SEWAGE DISPOSAL SYSTEM

MARYLAND STATE DEPARTMENT OF HEALTH*

SUBDIVISION Bethany Village ROAD 2630 Bethany Lane LOT 1, Sec. 2

APPLICATION

Bethany Village Sect 2 Lot 1

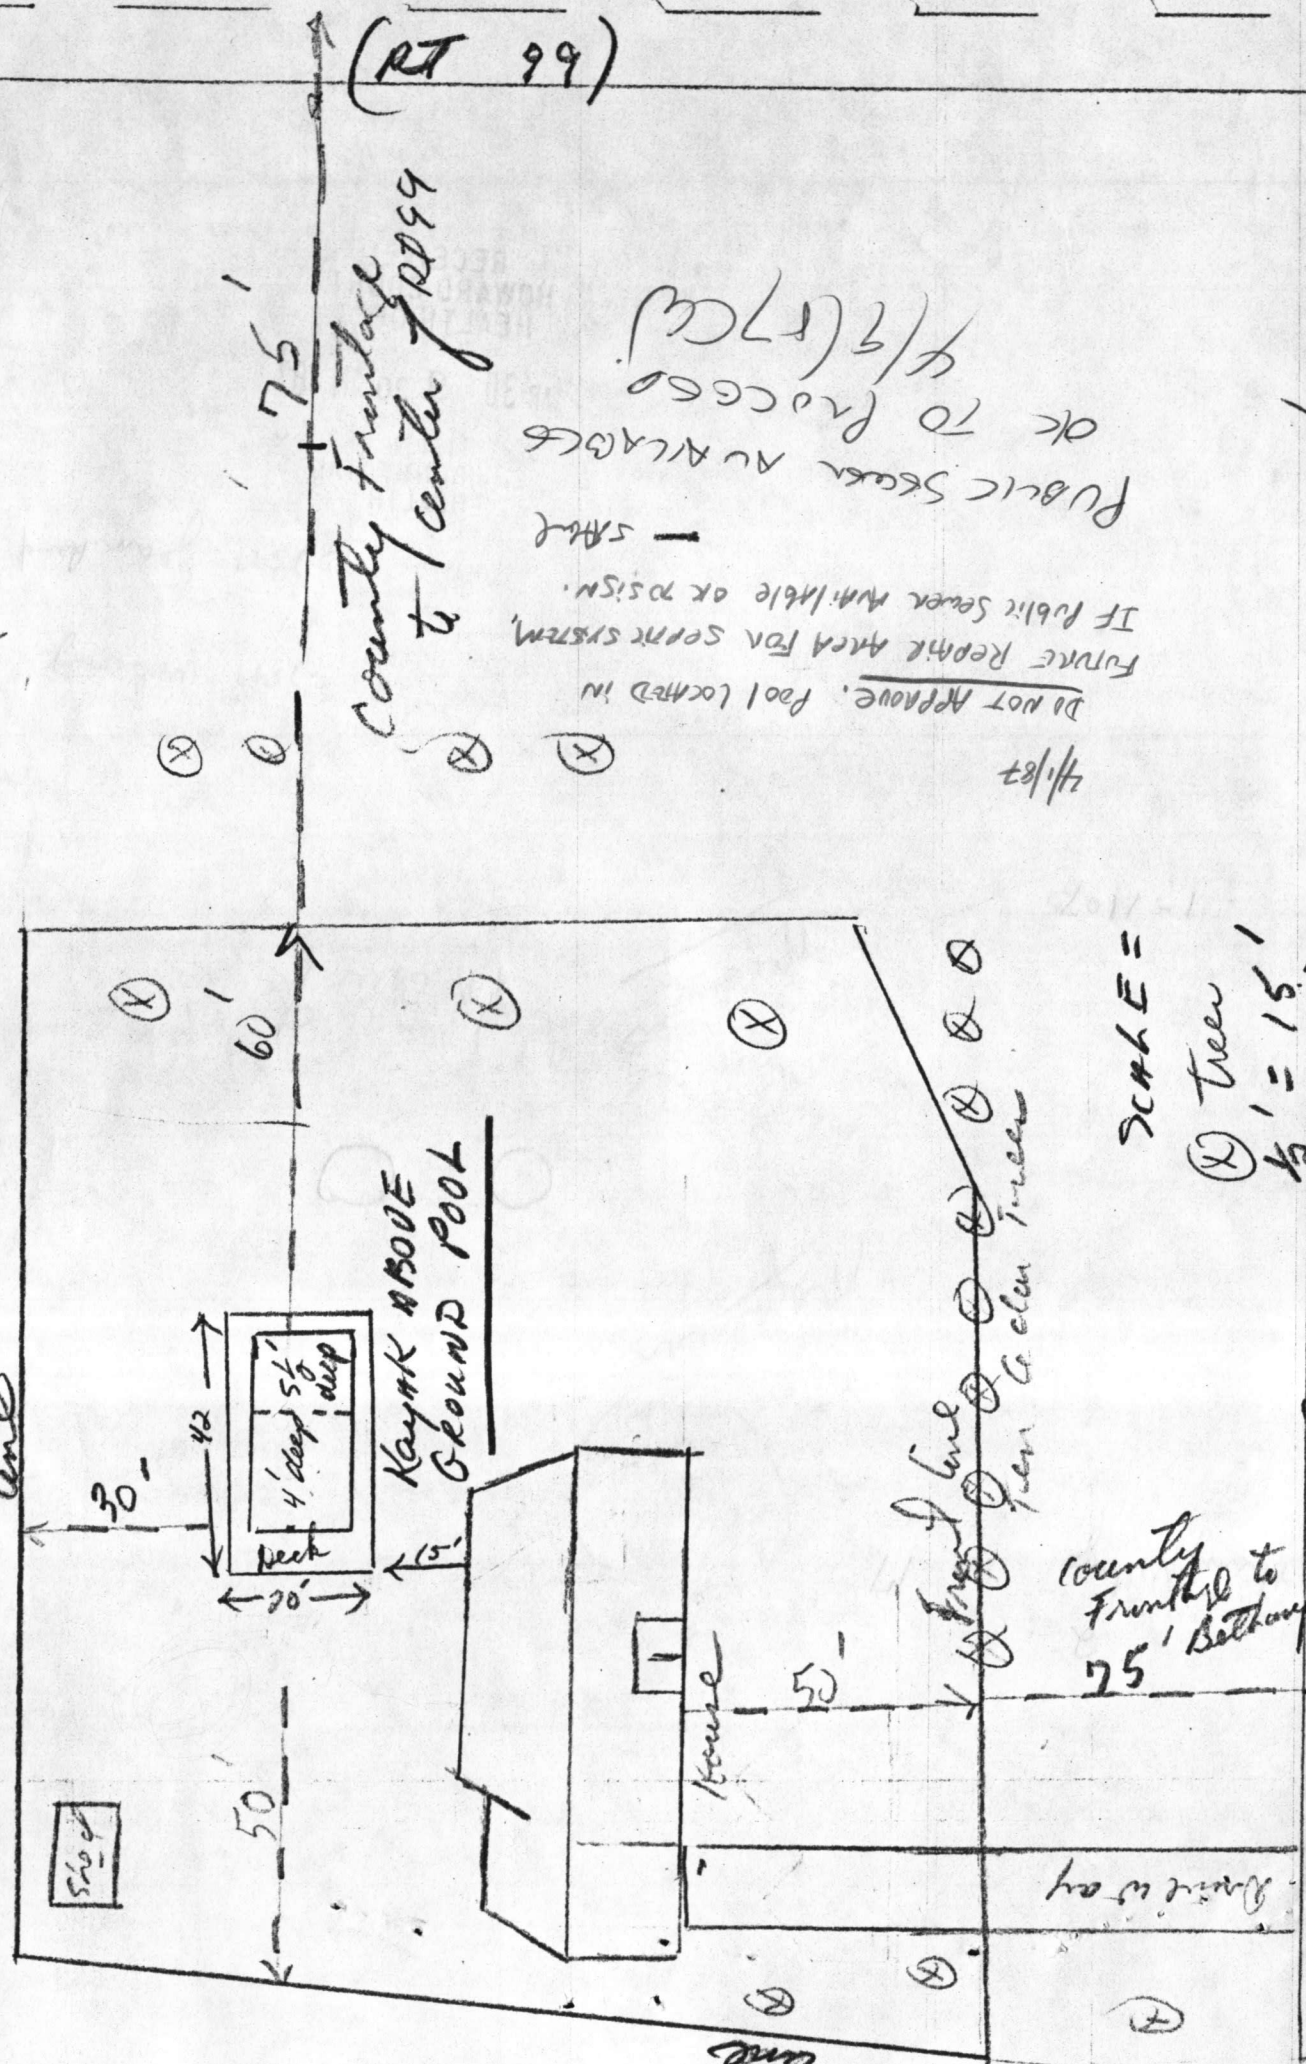
1/20/78 - Unsatisfactory Septer system plan
Following mistakes

- ① Wrong location of Dry Well
- ② Plans are not signed & certified as correct person who drew plans unknown
- ③ No elevations of the house, the ground or the septic system shown
- ④ Plans does not indicate whether public water or water well

1/25/78 - Revised Plans improved but
Following must be corrected

- ① Indicate on the plans that the lot has city water
 - ② Dry Well inlet is too deep in ground 7 1/2 ft Change Dry Well inlet to only 4 ft deep in ground & other elevations to comply
- called Wilder Building Corp & left message (OVER)

1/31/78 Revised plans rejected
① Too much slope on house to tank
② House is build out of ground
more than usual check with Builder

1/20/78 200pm - Wilder visited office
& agreed to draw new set
of corrected plans R H

1/26/78 Talked to Wilder
He will correct plans
tomorrow

2/1/78 - Plans Revised over phone
① Slope changed
② Wilder said split tank
& half of house out of ground
Revised Plans OK R/H

DO NOT APPROVE. Pool located in
 FUTURE REPAIR AREA FOR SEWER SYSTEM.
 IF Public Sewer Available OR POSSIBLE.
 - S.M.H. 4/1/87
 OK TO PROCEED
 4/9/87 (S.M.H.)
